D/DRC Case

1634 Main Street

DESIGN/DEVELOPMENT REVIEW COMMISSION
DESIGN REVIEW DISTRICT
HISTORIC AGENDA
EVALUATION SHEET
Case # 1

NATURE OF REQUEST: Request Certificate of Design Approval for exterior changes and Preliminary Certification for the Bailey Bill

EXTERIOR ELEVATIONS

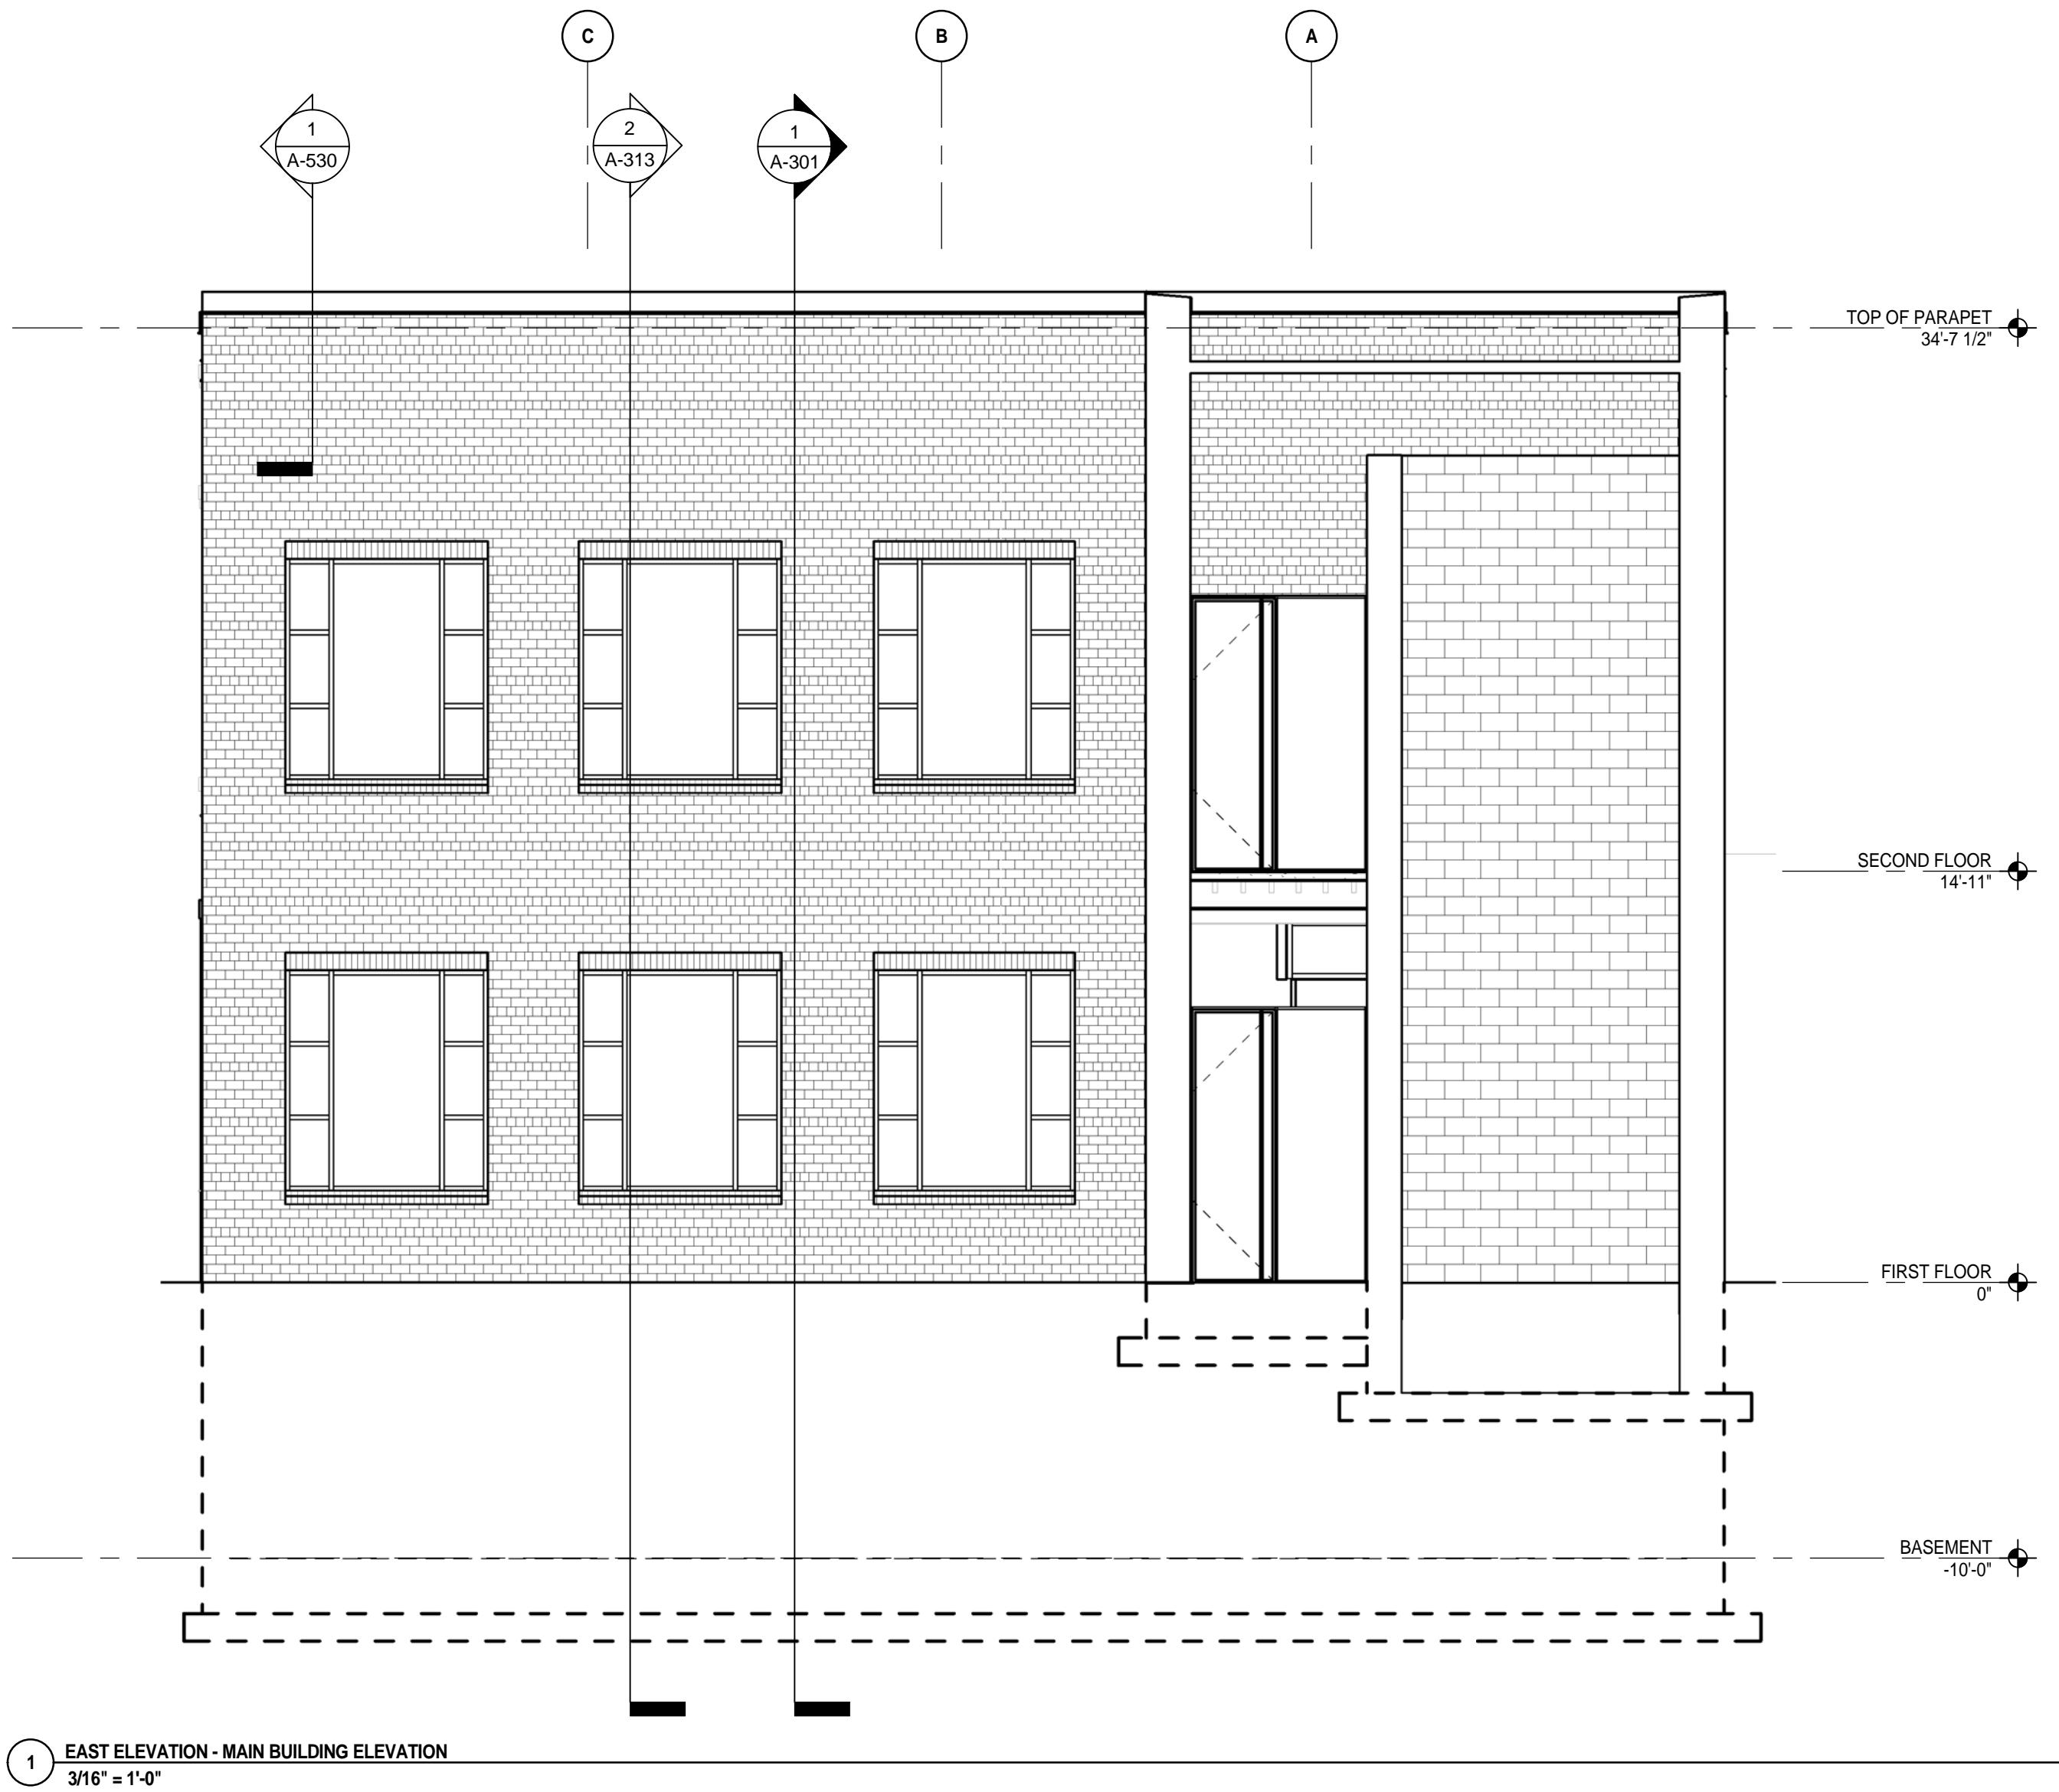
Other work on the building includes opening bricked-in windows along the south elevation, as well as a few doors; this is in an alley that is not public so only those parts visible to the public right of way are reviewed.

submitted at a later date. The submitted drawings are also not correct in their note to remove the iron star vents visible above the second floor windows along the south elevation.

The distinctive cream colored brick on the façade is being retained and repaired. The brick wall on the south elevation has already been painted before; it will be repaired and potentially repainted. Brick detailing in this wall shows the locations of door and window openings, some unusually shaped, with header courses and jack arches as lintels. These details will remain as infill brick is removed beneath them and new doors and windows are installed.
